Yorkshire Green Energy Enablement (GREEN) Project

Document 8.29.4 Applicant's Response to ISH4 Hearing Action Points

**Final Issue A
July 2023**

Planning Inspectorate Reference: EN020024

ILLUSTRATIVE LUMBY PROPOSED ALTERNATIVE ACCESS SKETCH

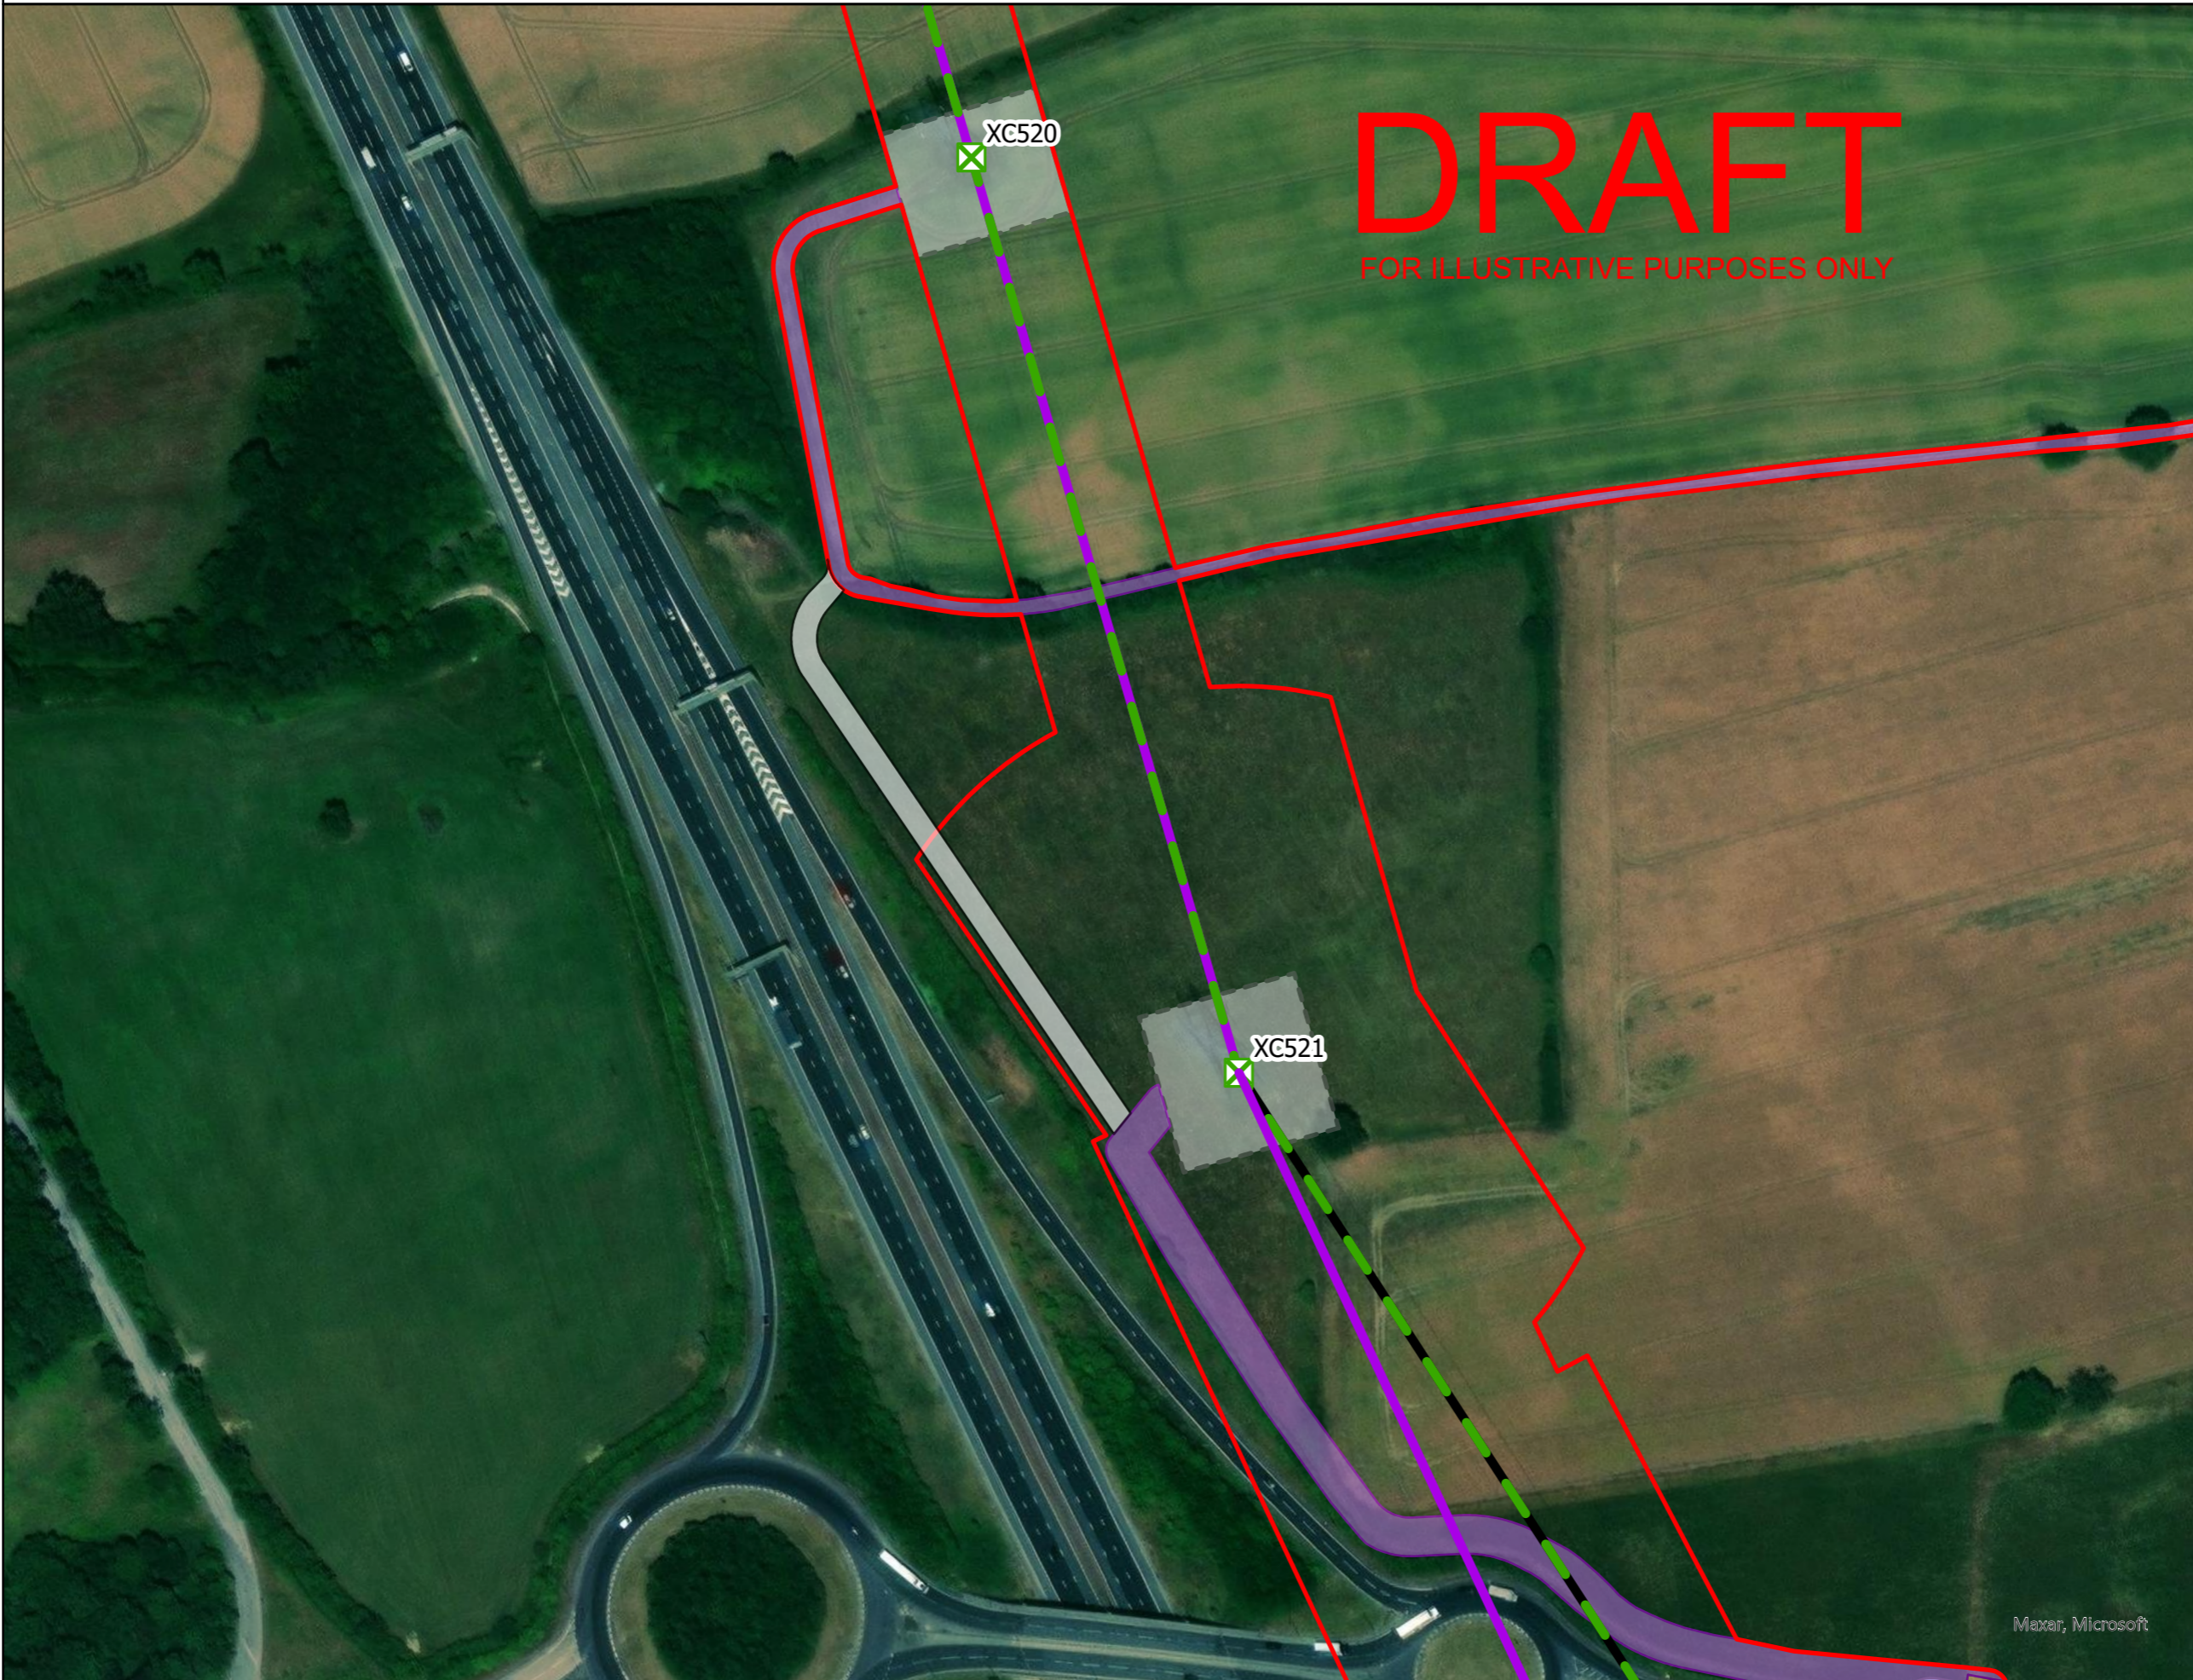
| Action No. | ExA description | Party | Deadline | Response |
|------------|----------------------------------------------------------------------------------------------------------------------------------------------------------------------------------------------|---------------|----------|----------------------------------------------------------------------------------------------------------------------------------------------------------------------------------------------------------------------------------------------------------------------------------------------------------------------------------------------------------------------------------------------------------------------------------------------------------------------------------------------------------------------------------------------------------------------------------------------------------------------------------------------------------------------------------------------------------------------------------------------------------------------------------------------------------------------------------------------------------------------------------------------------------------------------------------------------------------------------------------------------------------------------------------------------------------------------------------------------------------------------------------------------------------------------------------------------------------------------------------------------------------------------------------------------------------------------------------------------------------------------------------------------------------------------------------------------------------------------------------------------------|
| 8 | Set out the haul road alternative proposal to avoid HGVs through Lumby and provide update on progress on landowner agreement. | The Applicant | D6 | <p>The alternative proposal is set out in an illustrative plan in Appendix A to this document, which would see a temporary access extend from AP7. This would mean that HGV traffic would be able to use the bellmouth AP7 and travel to pylon XC521. The access proposal would consist of track matting. The use of this proposal would mean that HGV access would not need to be routed through Lumby, however the road through Lumby would still be used for LGV movements and for future maintenance requirements.</p> <p>Heads of Terms were already agreed with the affected landowner prior to this proposal being identified, and a meeting has taken place to discuss the alternative which was positively received. The alternative access route will be required to be agreed by the landowner as part of voluntarily agreement and the option agreement signed by the landowner.</p> <p>If the option agreement is signed within the timeframes of the Examination, this would enable the CTMP (Document 5.3.3F(C)) to be updated to reflect the change of route for HGVs as detailed above. However, as it can take some time for an option agreement to be finalised and signed which may not take place prior to Deadline 7, National Grid consider an update to the CTMP could be made to confirm as part of the routeing strategy the flexibility for access to pylon XC521 to be taken via Access Point 7 for HGV access should the voluntary agreement be in place.</p> |
